**REGULAR MEETING  
CITY OF RIALTO  
TRANSPORTATION COMMISSION  
AGENDA**

Wednesday  
October 5, 2016  
6:00 p.m.

Locust Avenue Warehouse Focused TIA 2<sup>nd</sup> Review  
(Gene Klatt, P.E., Lockwood Engineering)

Coffee Bean & Tea Leaf Focused TIA  
(Robert G. Eisenbeisz, P.E., Public Works Director/City Engineer)

EXHIBIT 1-4: TRUCK ACCESS

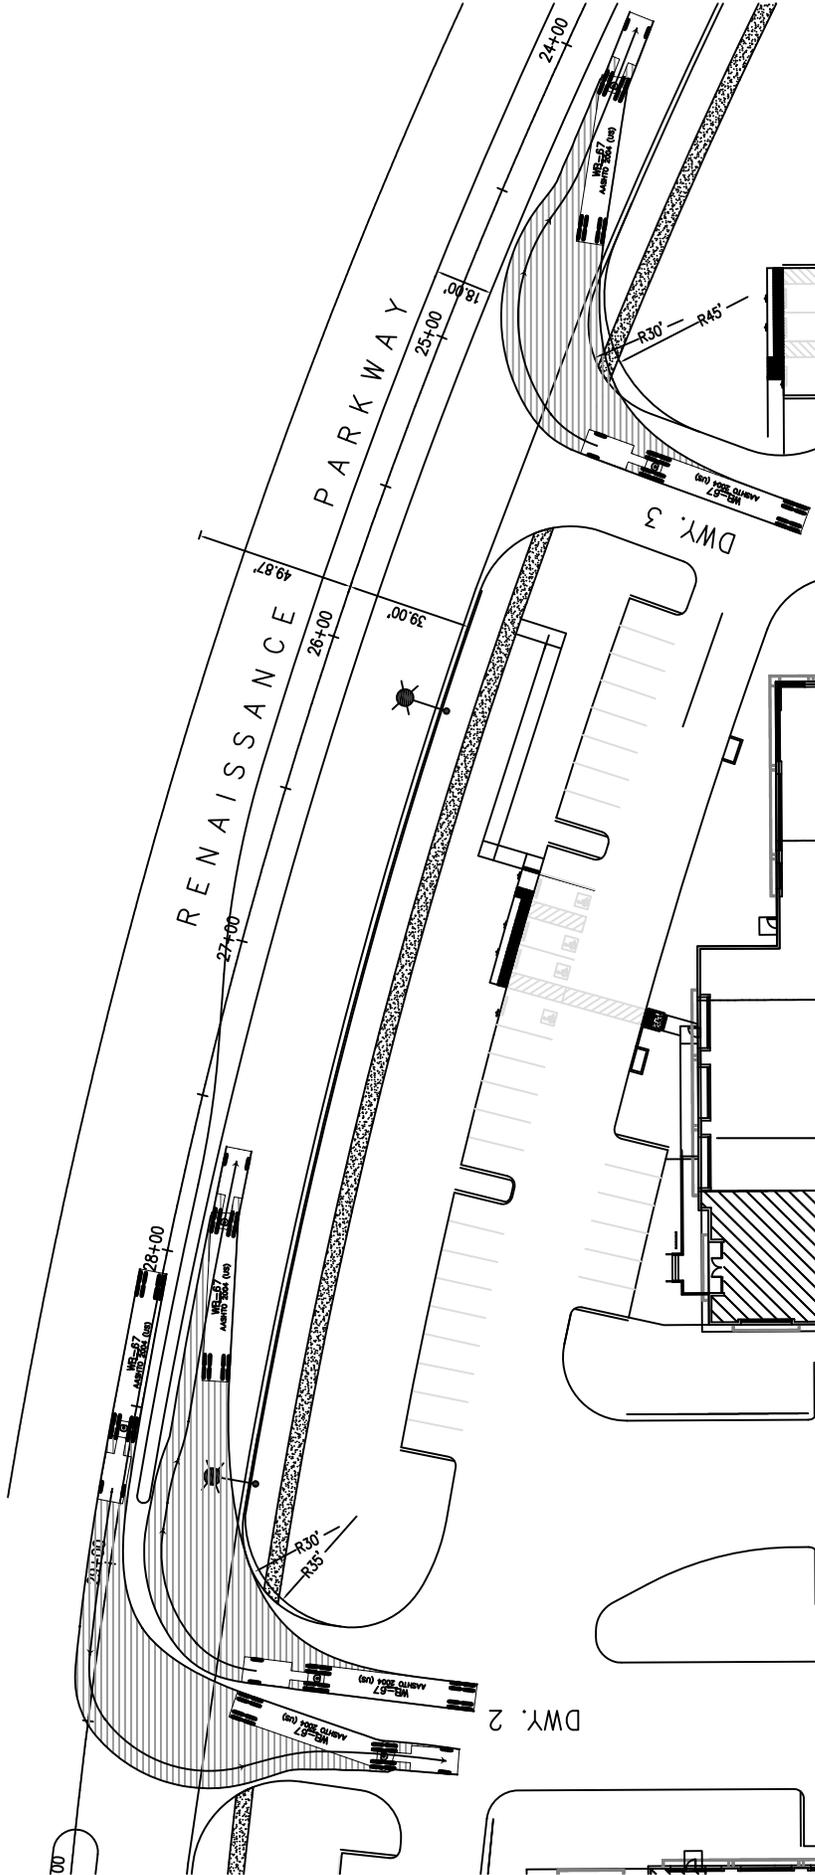
This project is the construction of three separate buildings totaling 340,715 square feet and listed as warehouse development. The site plan is shown on **page 2 of the TIA as Exhibit 1-1** which is included as **Attachment 2**. One building is 210,628 square feet, the second is 77,047 square feet and the third is 53,040 square feet. The project did require a zone change to allow warehouse construction and that has been processed through Development Services Department. The scoping agreement showed four proposed driveways but the final TIA proposes only three driveways. The TIA does not state the size of the driveways but the original scoping agreement did state the sizes. Driveway #1 onto Palmetto Avenue is passenger vehicles only and provides full access and was listed as 26 feet wide. Driveway #2 is onto Renaissance Parkway approximately 832 feet east of Palmetto Avenue, is proposed as a full access driveway for both trucks and passenger vehicles, and is approximately 50 feet in width. Driveway #3 is approximately 1247 feet east of Palmetto Avenue and 415 feet east of driveway #2 and is for both passenger vehicles and trucks but is restricted to right in/right out movements. It was listed as 40 feet wide. On **page 21 in Exhibit 1-4**, which is included as **Attachment 3**, driveways #2 and #3 are shown as having radiuses 35-feet on driveway #2 and 45-feet on driveway #3 to allow larger trucks to make the turns into and out of the driveways and clear the median. Driveway #3 is approximately 850 feet from the proposed main access to the development on the northwest corner of Renaissance Parkway and Alder Avenue, which the Commission discussed some months ago. Truck circulation appears to be dead end at all truck docks. That is, trucks enter and exit the loading docks in only one direction and there is no circulation around the buildings. Building #1 does appear to have passenger vehicle circulation but it does not appear trucks could make the required turns to circulate around the structure.

## FIGURE 5-2

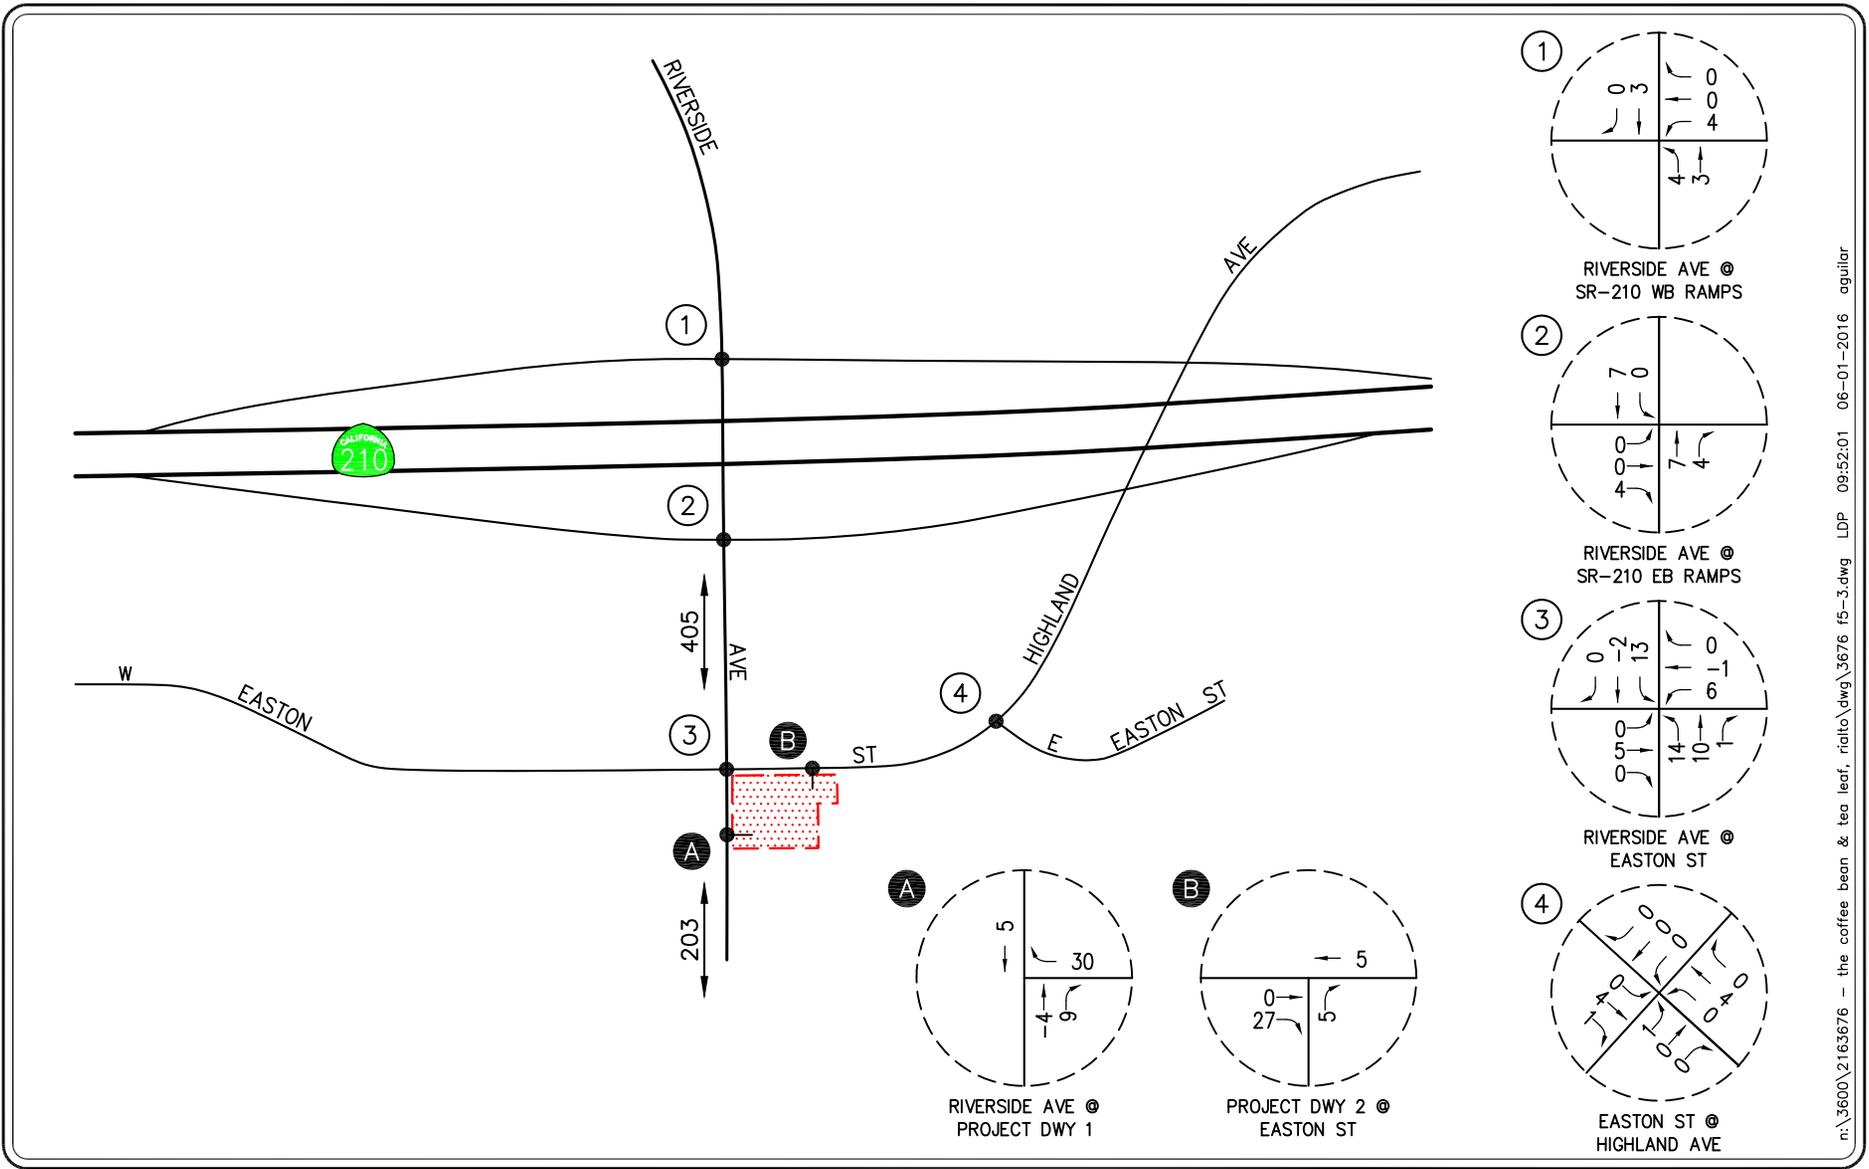
**Figure 5-2 on page 15B and Figure 5-3 on page 15C (Attachment 6)** appears to be for the same period, AM peak hour, project traffic only, yet show different results. It also seems that it shows only the net difference in/out at both driveway A and B. That is, the numbers shown for driveway traffic reflect only the net after pass-by deductions, which is incorrect. The driveways actually see the total traffic in and out and combined should reflect 166 AM peak hour trips and 71 PM peak hour trips indicating the actual numbers using the driveways. This affects later queue analysis and operational analysis of the driveways. It is also not clear in the figures what the negative numbers reflect or how they affect the analysis.

FIGURE 11-2

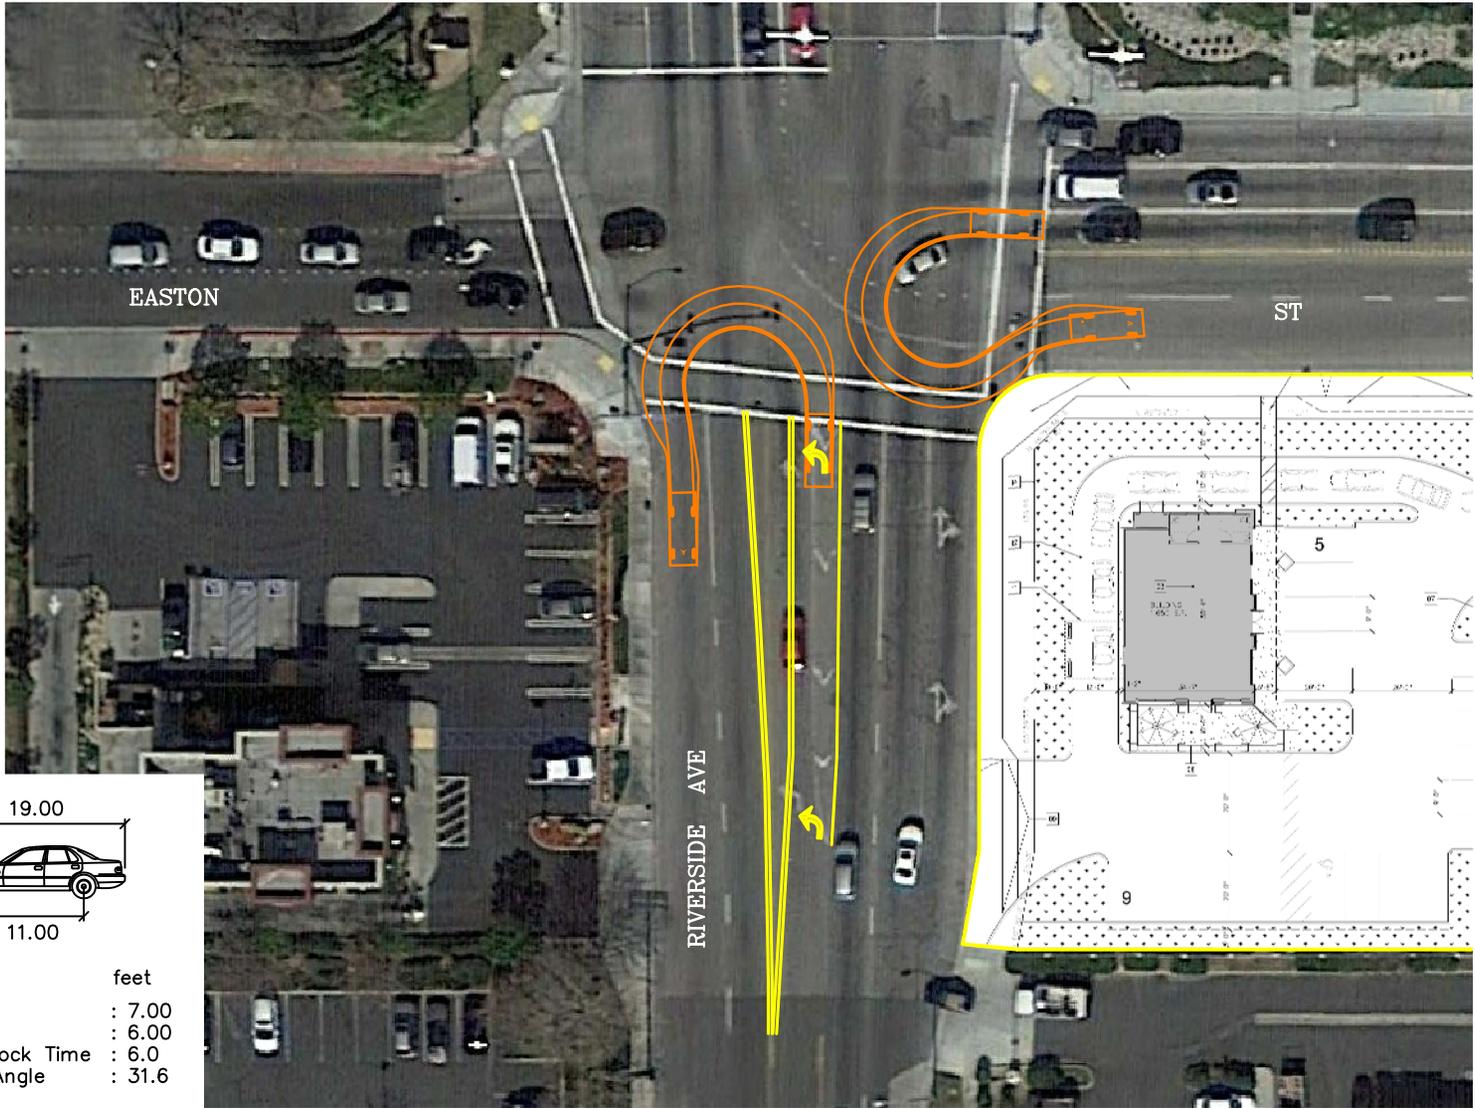
**Figure 11-2 on page 35B**, which is included as **Attachment 7**, shows how a sedan size vehicle might make U-turns but does not show potential conflict with opposing U-turns or how full size pickup or other larger vehicles might make such a U-turn. It is not clear how signing could allow U-turns for smaller vehicles but prohibit it for larger vehicles. The Easton Street U-turn does seem to require going south of the intersection to complete the turn and both U-turns have wheel tracks against the curb as seen in figure 11-2.
